LINCOLN & DRANSFELDT

NORTHWEST 1/4 OF SECTION 15, TOWNSHIP 6 SOUTH, RANGE 66 WEST OF THE 6TH P.M. COUNTY OF DOUGLAS, STATE OF COLORADO

WATER AND SANITARY PLANS

LINCOLN & DRANSFELDT
SANITARY PLAN & PROFILE

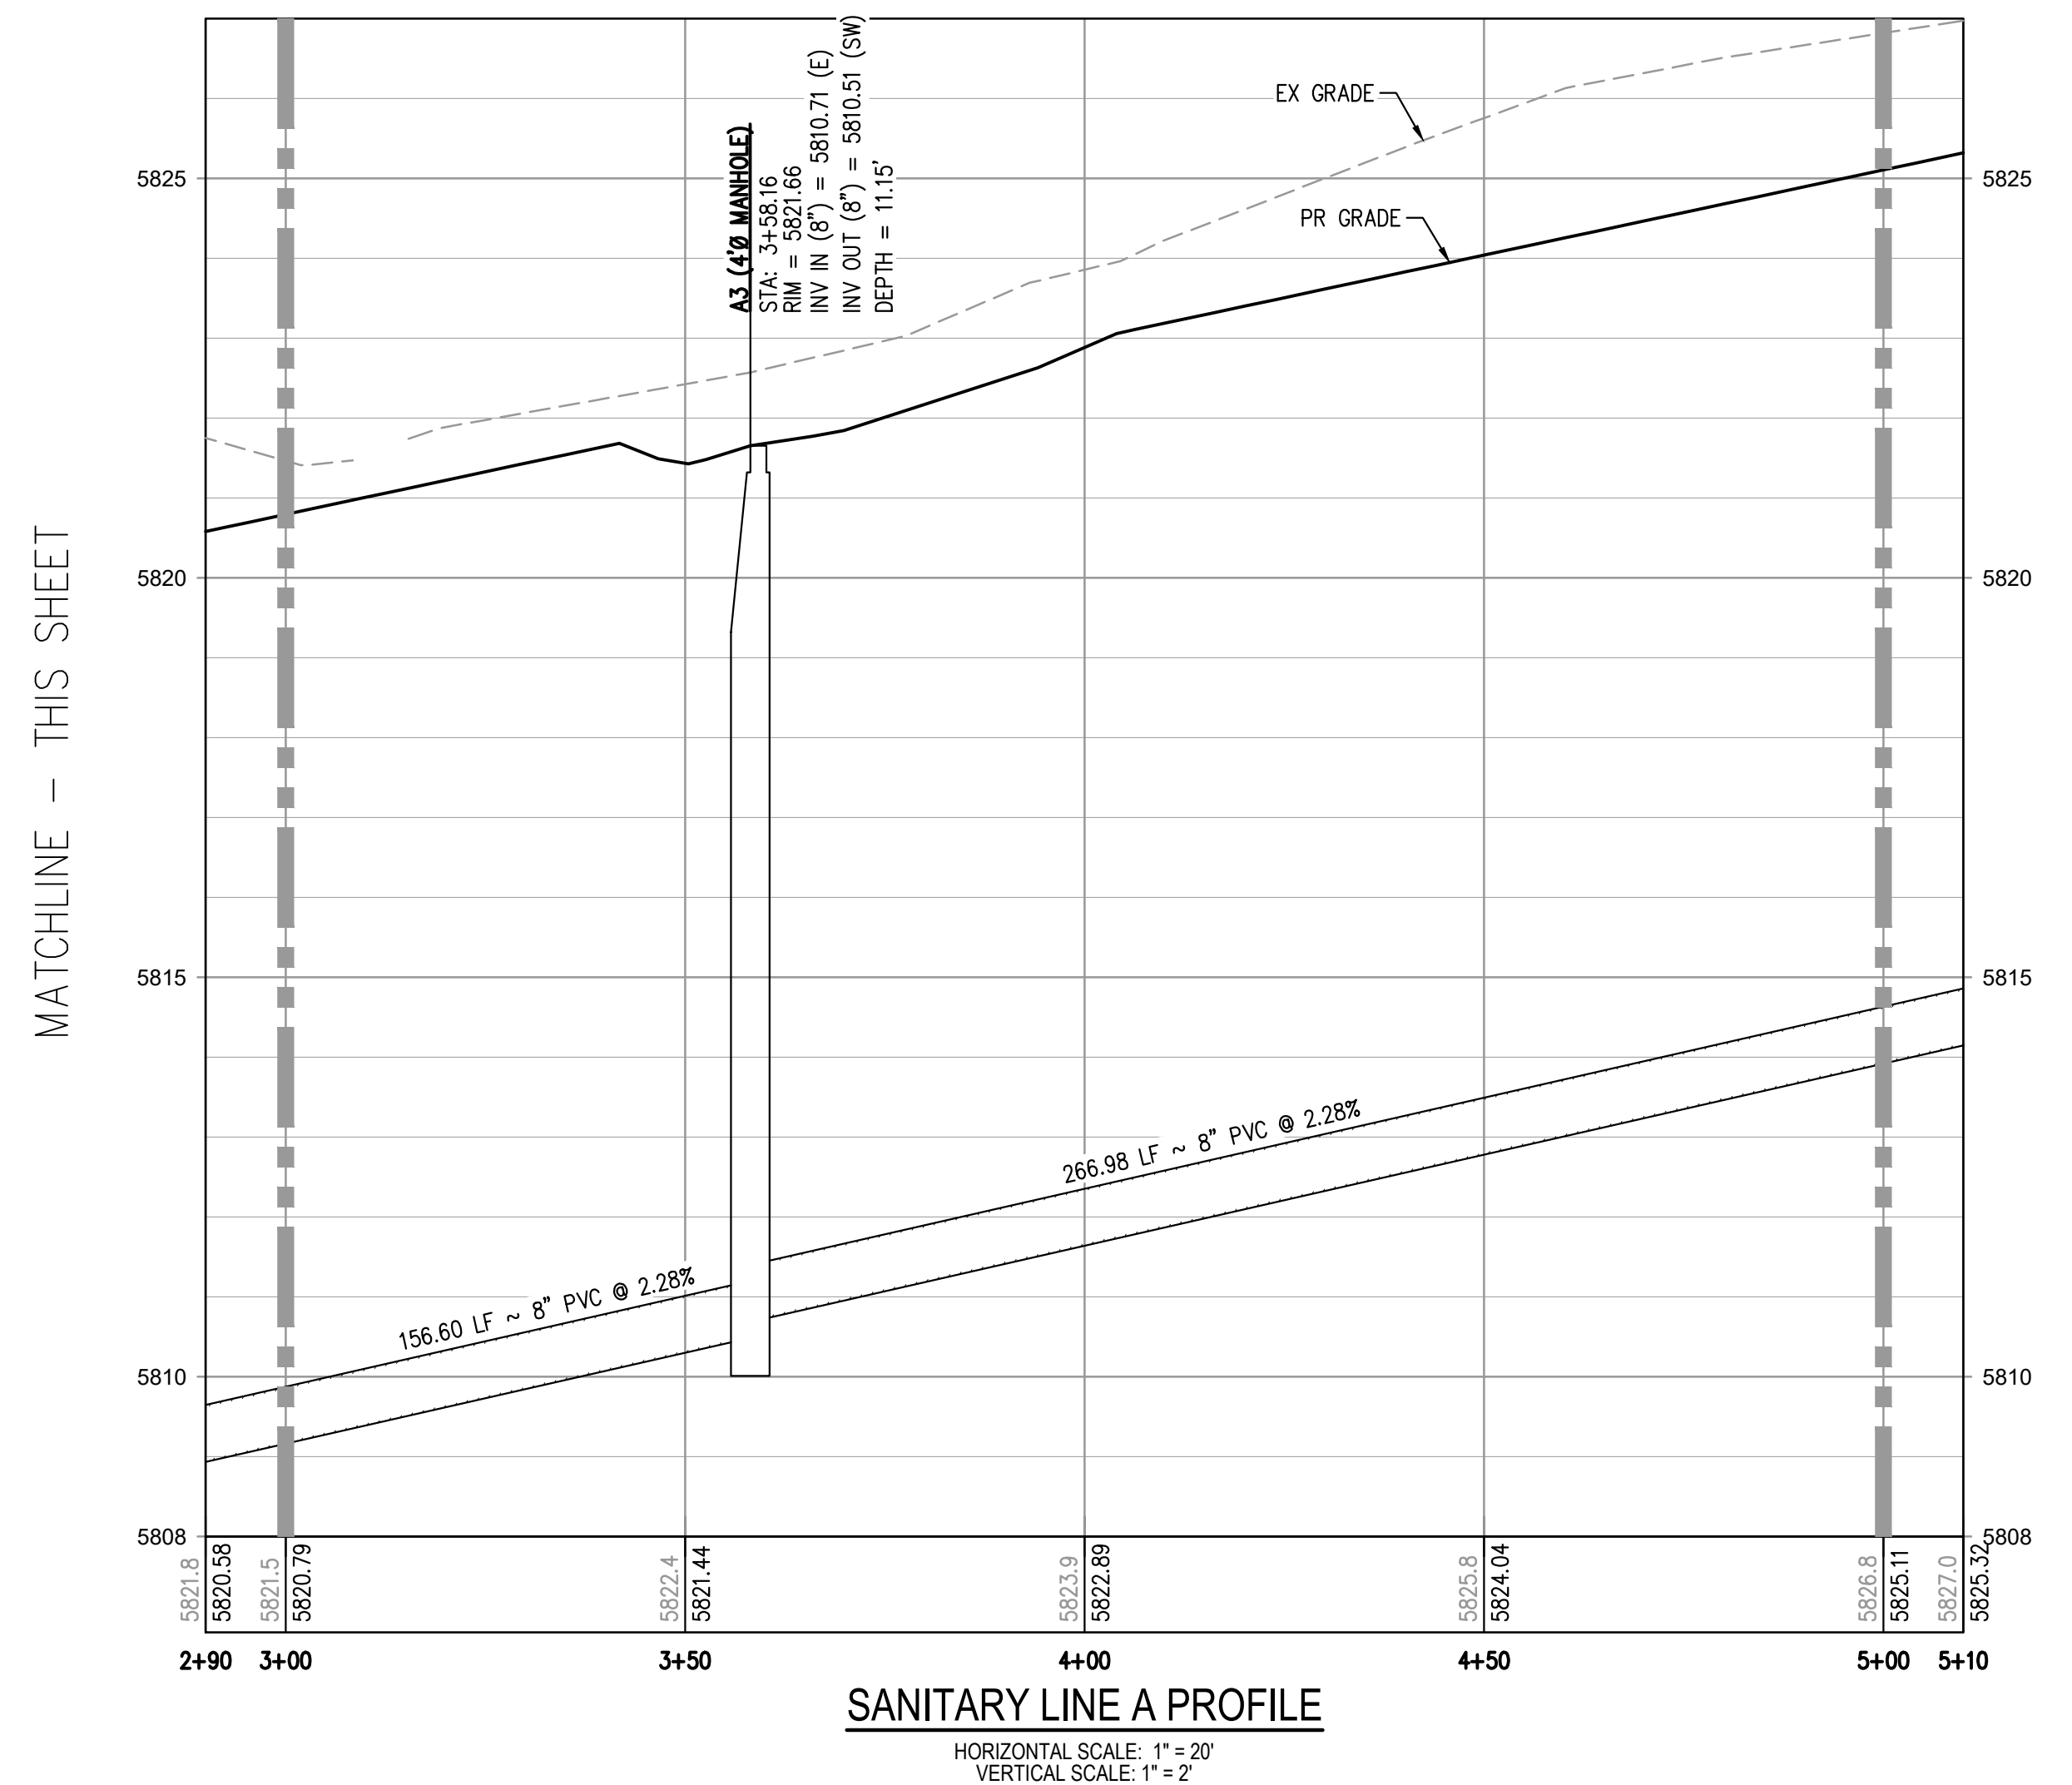
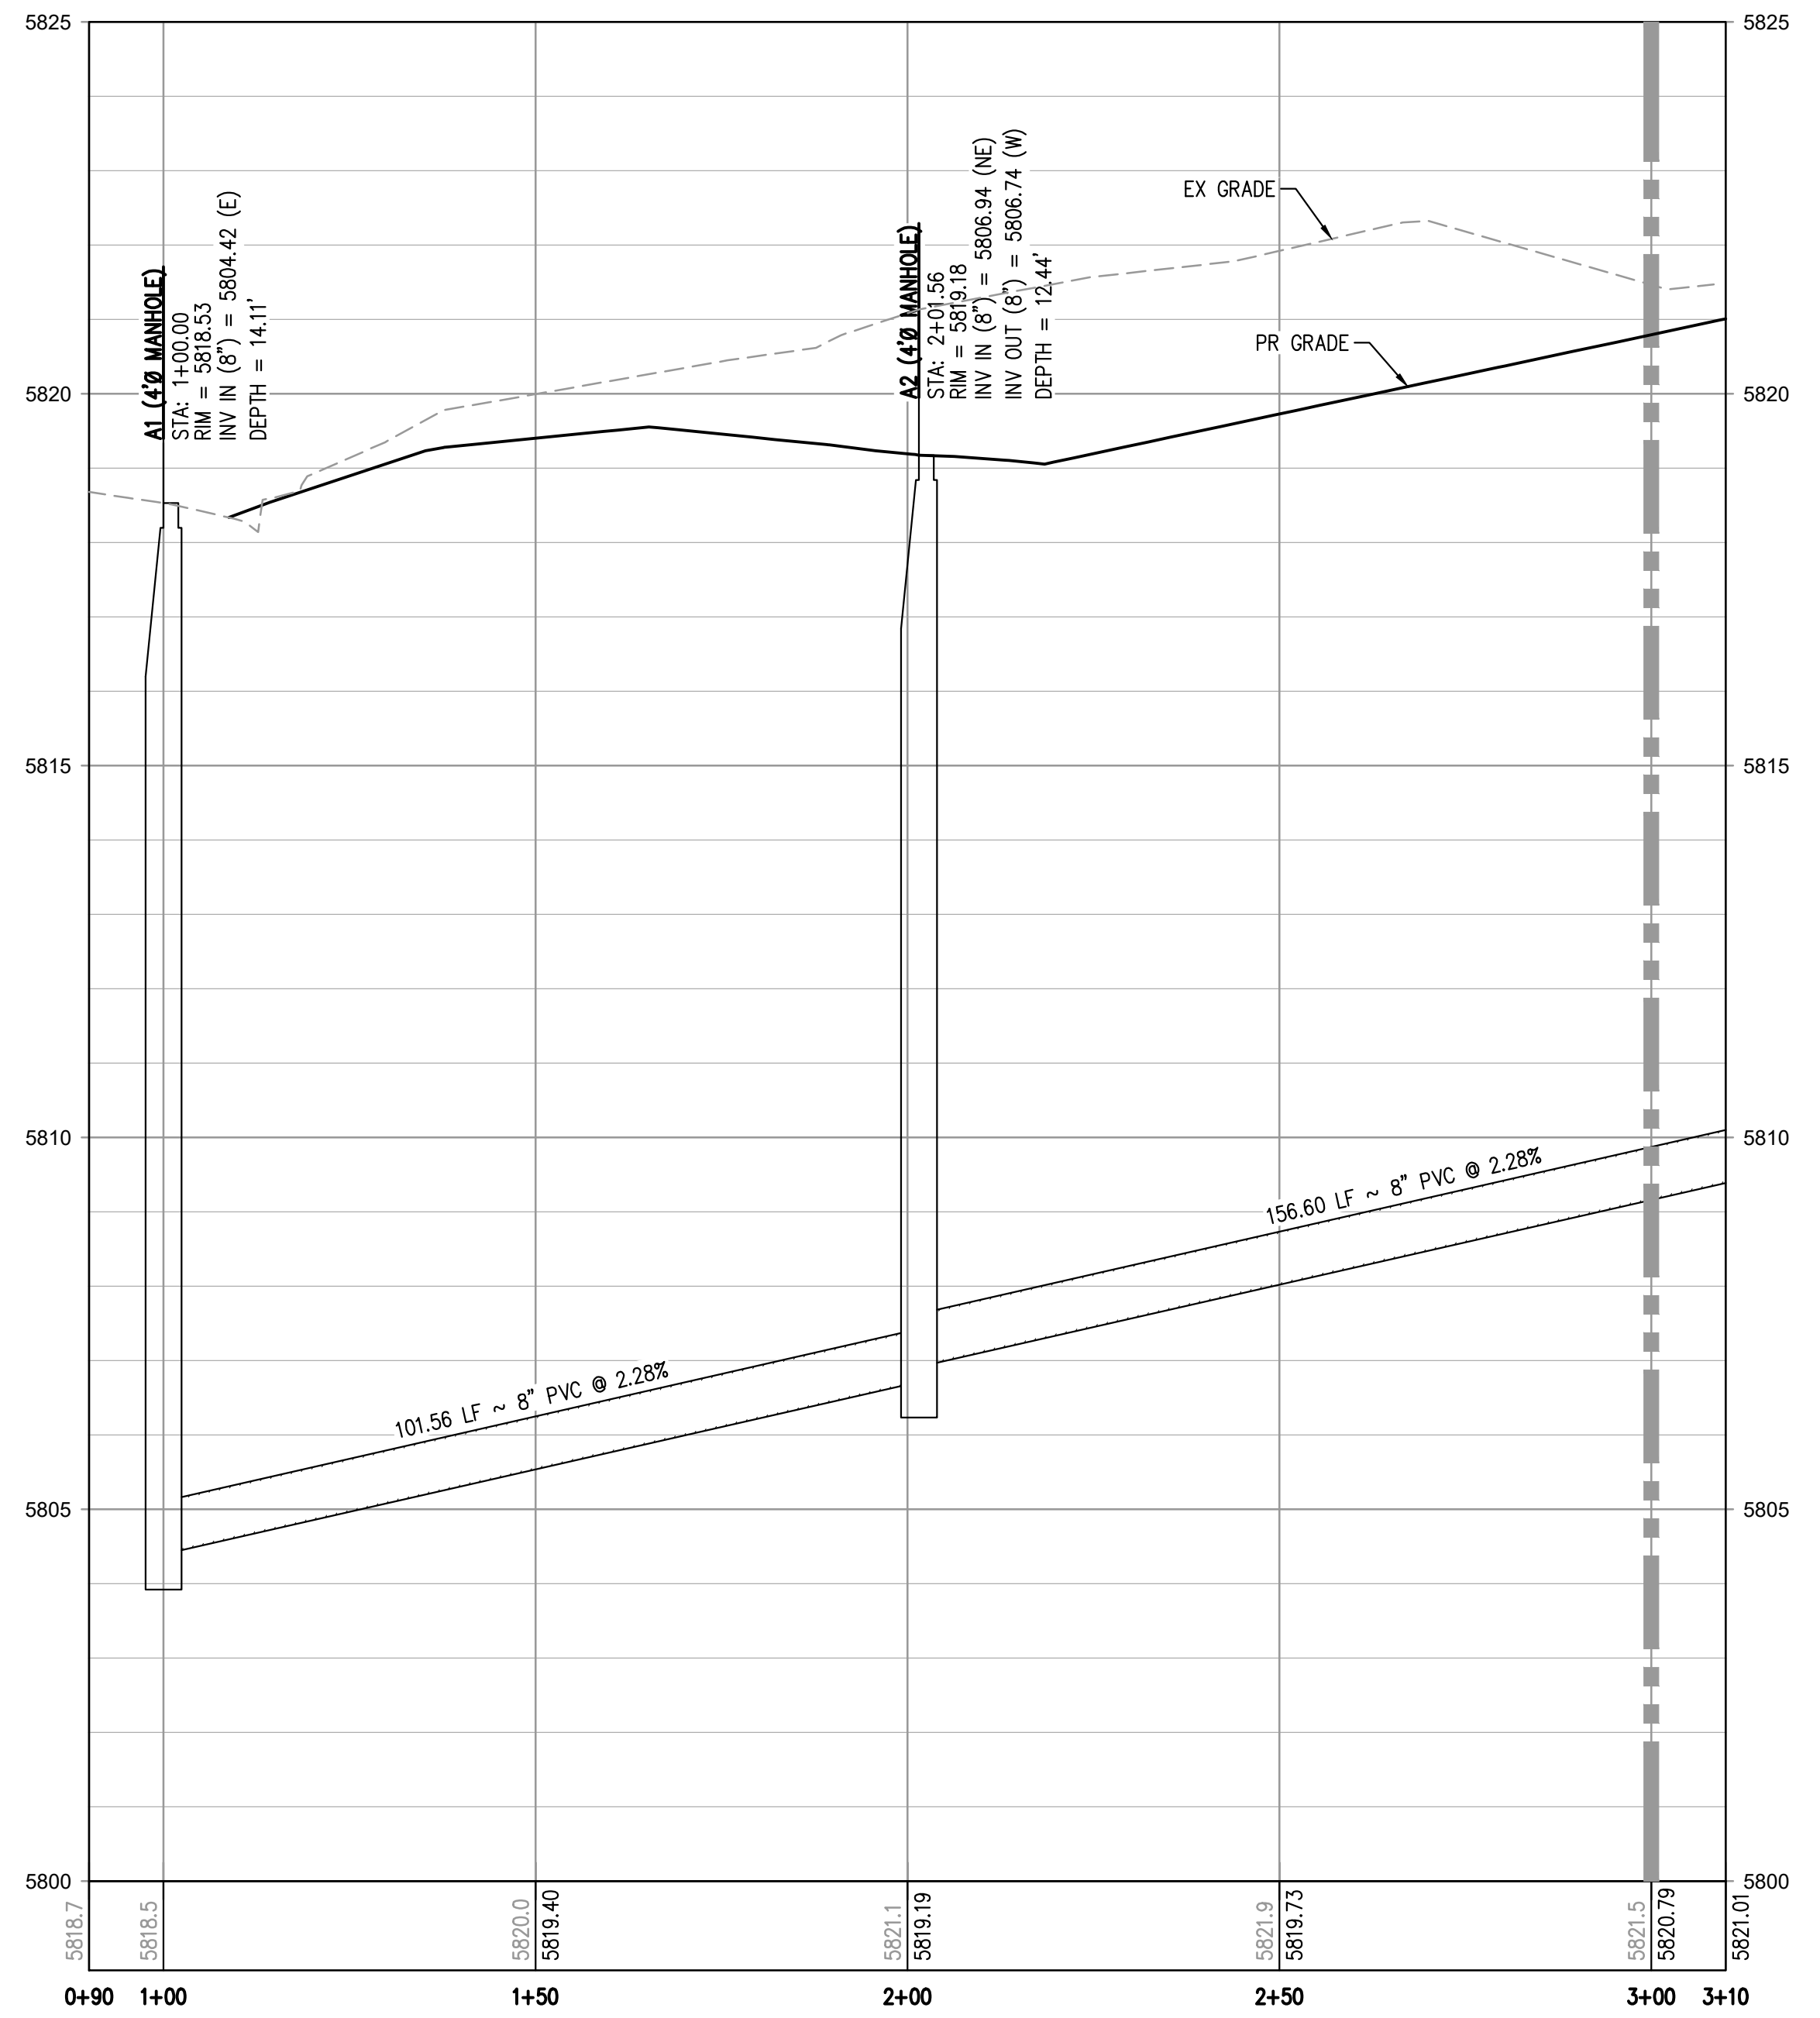
Call out All Crossings
